# MARION

Early Design Guidance #2  
May 01, 2018  
SDCI# 3027315

## EDG Meeting #2 - Introduction and Purpose

EDG #1- TOWER TOP

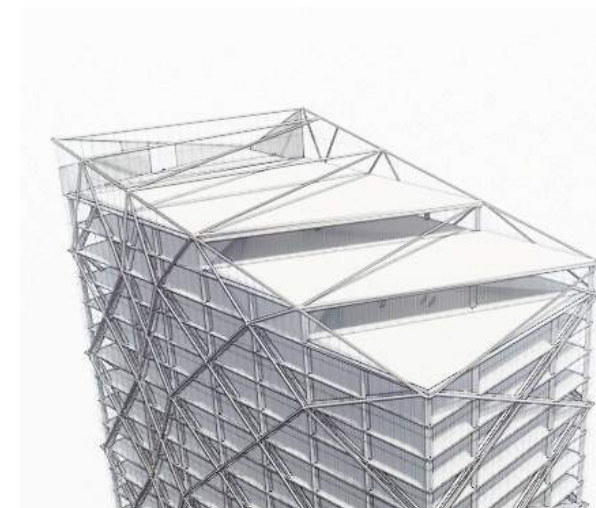
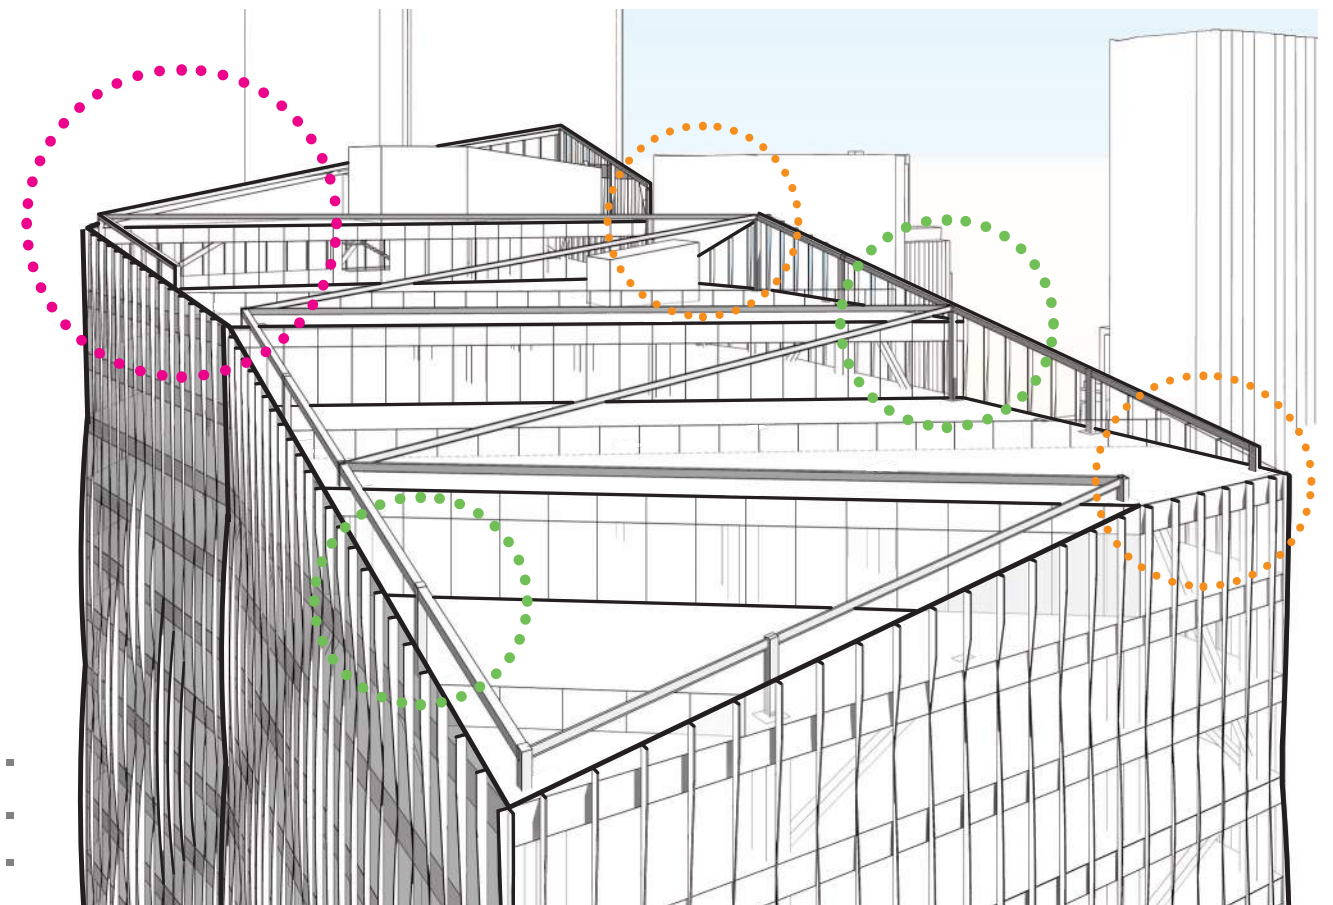
**Comment 3c.** Related to the top of the tower, the Board was supportive of a sloped roofline, however, the Board agreed the form should relate to the diagonal bracing structure to reinforce the design concept. (A2, B4, C2)

**3c Response:** The updated design approach maintains the sloped roof / parapet line as supported by the board; the modulated massing and 'notch' at the Third Avenue roof line better resolve the building height and visual composition. The change of direction to sculpted fins for façade articulation de-emphasizes the diagonal bracing structure on the exterior, and the stepped upper levels carried forward in the current design provide visual interest in the massing rather than by the shaping of the parapet line.

OFFICE LOBBY + RETAIL OPTIONS

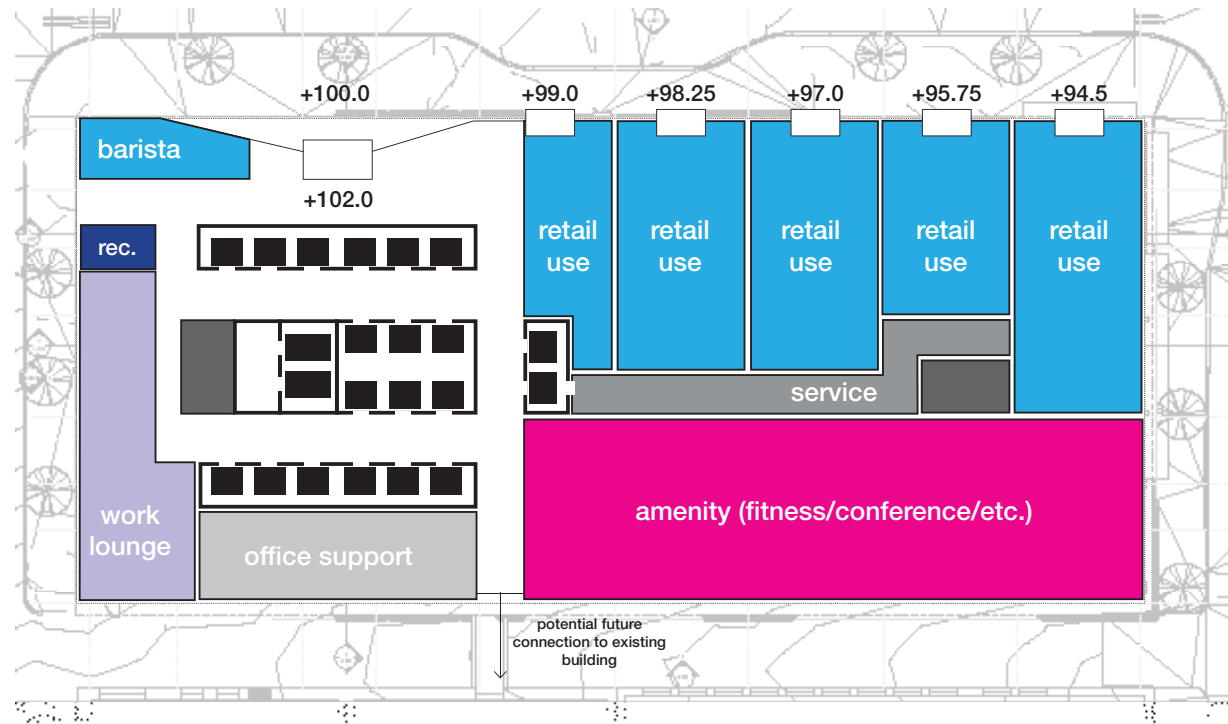
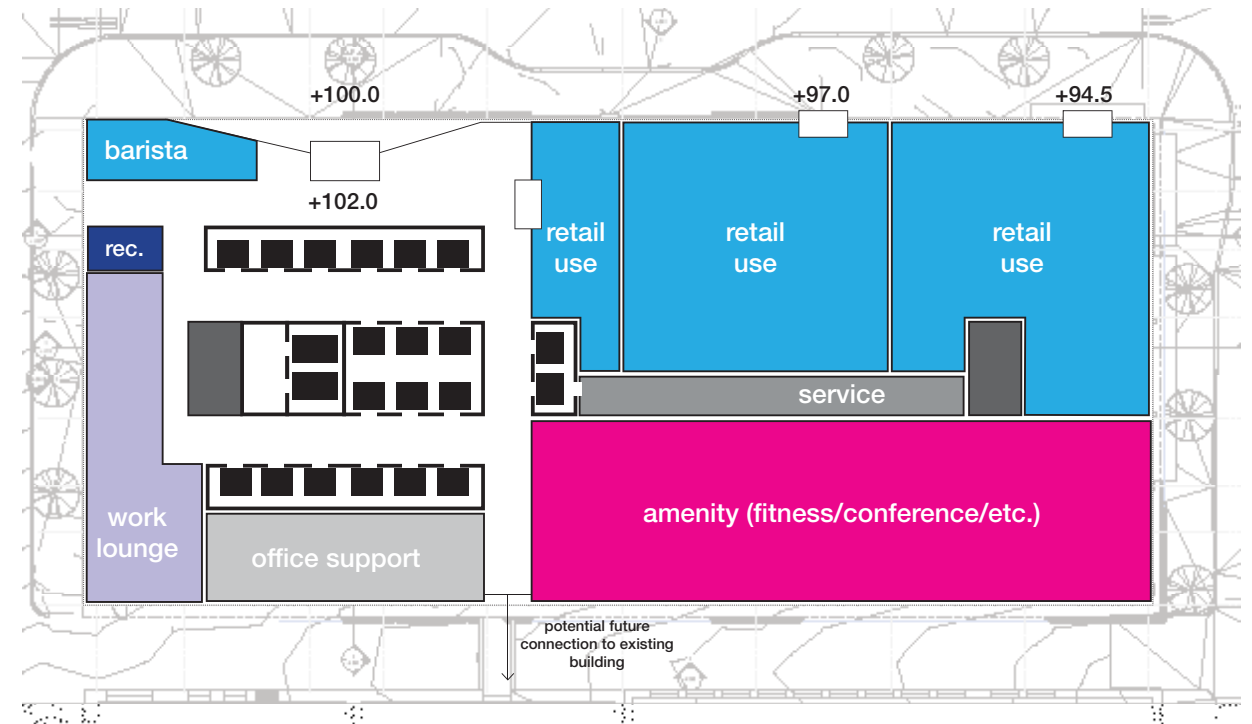
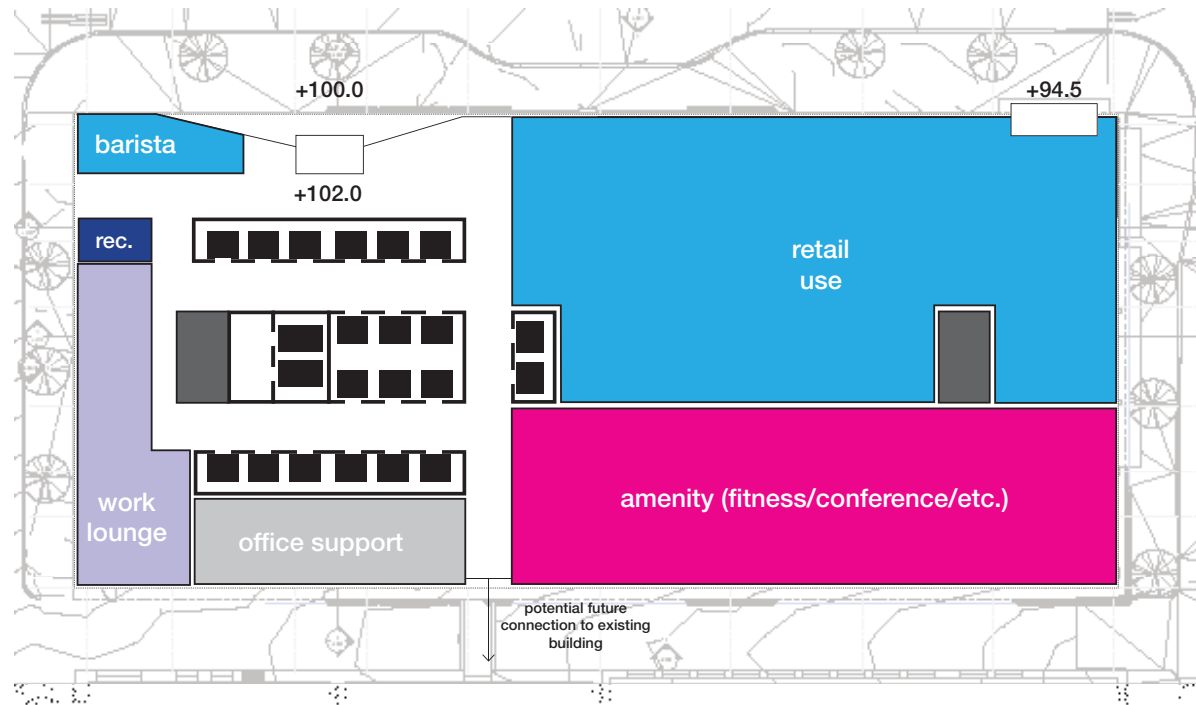
**Comment 2A:** The Board Discussed The Circulation Zone Of The Double-Sided Retail, Referred To As A "Market". While The Board Supported The General Design Intent Of A Market, The Board Was Concerned With The Visibility And Accessibility Of The Retail Frontage And Noted That Similar Projects Such As 400 Fairview, Continue To Have A Strong Street Presence. To Enhance The Visibility Of The Retail Frontage And Improve Access To The Spaces, The Board Recommended Resolving The Circulation And Incorporating Accessible Routes Through To The Retail Spaces. The Board Also Agreed Multiple Entries And Signage Should Be Factored Into The Design And Requested Information About These Elements For The Next Meeting. (C1, C4, D1.1, D3, D4)

**Comment 2B:** For The Elevator Bank Frontage Along Third Avenue, The Board Recommended Studying And Possibly Adding Unconventional Retail Such As Kiosks Or Extending The Market To The Corner To Extend The Retail Frontage, Improve The Circulation Path Through The Retail Spaces And Enhance The Streetscape Experience And Justify The Departure Related To Street Level Uses. (C1, D1.1, D3, D6)

**2a & b Response:** The design team is continuing the development of the design for the retail program towards the more open 'market' approach as supported by the Board. While more typical segregated retail spaces with separate entrances could be implemented in order to more directly comply with the street use requirement, the market approach will create a more activated ground level experience. The importance of incorporating opportunities for retail presence expression at the street façade is understood and is anticipated to be supported by use of signage at the façade / canopies, and within the tall interior seating / circulation zone.

The current ground level plan incorporates a mid-block retail entry in addition to the corner, and the interior planning will create zones for more 'kiosk' retail functions adjacent to the building entry to more consistent with the 75% frontage requirement of the code. These will be illustrated in more detail at a subsequent meeting.

3RD AVENUE AND MARION STREET- EDG #2

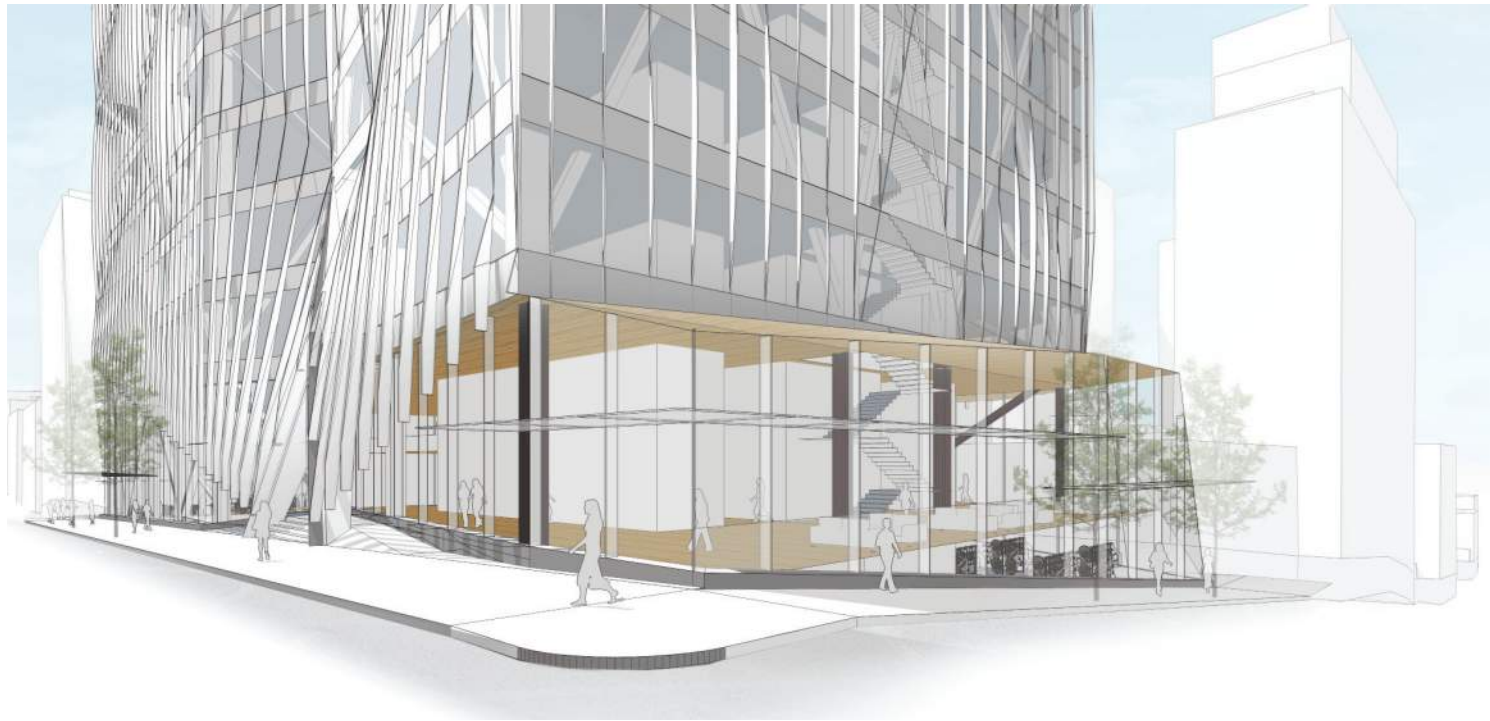
**Comment 2c:** Echoing public comment, the Board recommended minimizing the presence of blank walls and improving the ground level experience along Columbia and Marion. The Board strongly supported the stair along the Columbia frontage as it breaks up the blank wall condition and recommended strengthening the streetscape along Marion. The Board also agreed with public comment related to landscape and recommended incorporating landscaped areas and storm water planters at the ground floor to enhance the streetscape edge along the view corridors and address the pedestrian scale at the street level. (C1, C3 D1.1, D2, D6)

**2c Response:** The design team will continue to develop the design to minimize blank wall conditions along Marion and Columbia. On Marion, the updated design direction composes the 'work lounge' lobby element more directly into the geometry of the tower massing, and extends the glazed envelope of the volume down the lower alley elevation to provide more openness and a degree of transparency to the bike commuter facilities beneath.

Along Columbia, the updated design pulls tower skin articulation up to create a larger, more open volume for retail uses and to better reveal the interior structure. The termination of the tower stair previously shown in this location is intended to be pushed to below the lobby level, to create more contiguous floor area for retail functions. These elements will continue to be explored and refined.

3RD AVENUE @ ENTRY

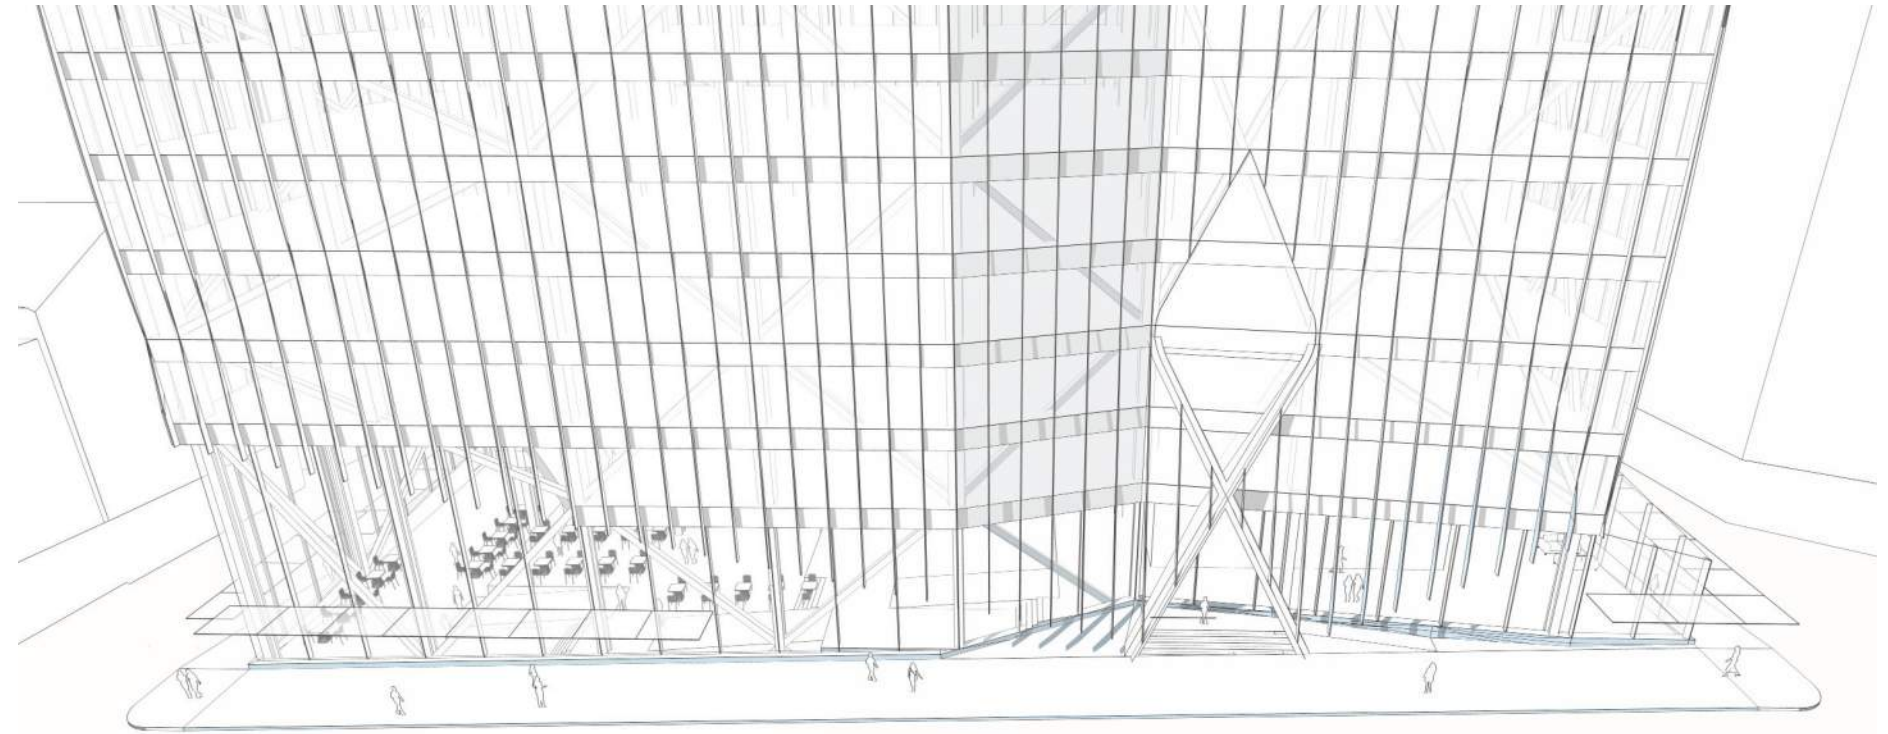
**Comment 2d:** The Board agreed they did not support the requested departure related to street level uses as shown. The Board indicated strengthening the visibility and accessibility of the retail frontage, extending unconventional retail uses to the corner and resolving the exoskeleton relationship to the ground level would help justify the departure request. (C1, D3)

**2d Response:** The preliminary design showed a distinct but abrupt change of design language between the geometry of the tower and the datum of tall 'podium' podium element. The updated tower base design more strongly integrates the tower articulation with the street level spaces, and creates higher degree of visibility and extent of retail uses along Columbia.

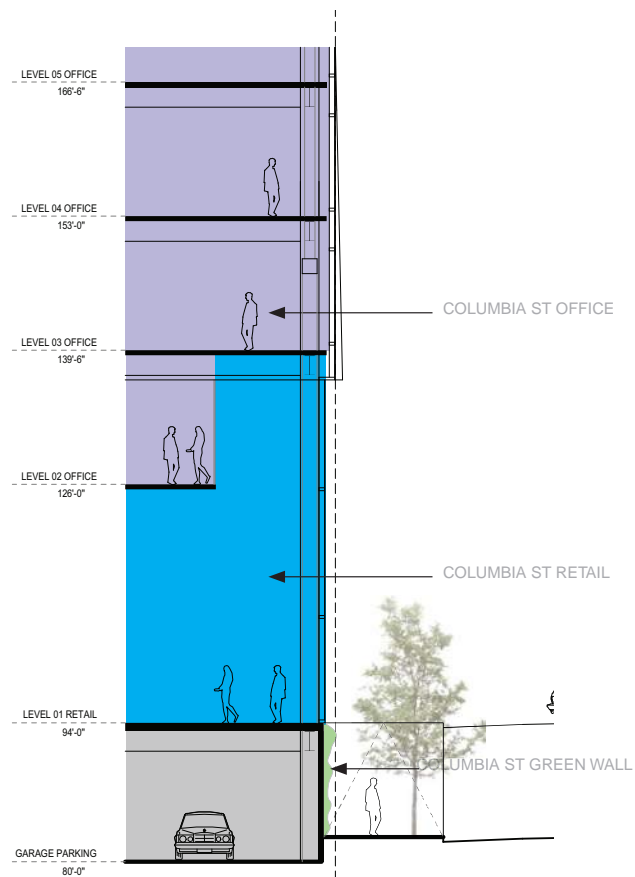
**Comment 3a:** The Board supported the design intent to pull up the tower skin and establish a connection between the exoskeleton and the ground plane, as represented in the early renderings. The Board agreed a consistent logic of how the exoskeleton end angles meet the ground floor plane should be applied to reinforce a cohesive design and stressed the importance of thoroughly studying how the exoskeleton terminates at the ground. (B4, C1, C2, C6)

**Comment 3b:** For the Third Avenue and Marion Street corners, the Board recommended thoughtfully studying the transition between the lobby pavilion and the exoskeleton structure by treating the intersection of the two consistently with the same logic as applied to the rest of the building. (B4, C1, C2)

**3a & b Response:** The updated design much more strongly integrates both the base and top into the overall massing modulation and faceted language, in a more unified geometry than the more segregated tower and podium language of the preliminary concepts. The proposed use of vertical fins as the façade treatment to add texture and more subtly reveal the interior structure is a simplified and more direct approach that will better distinguish between the interior structure and the exterior enclosure.
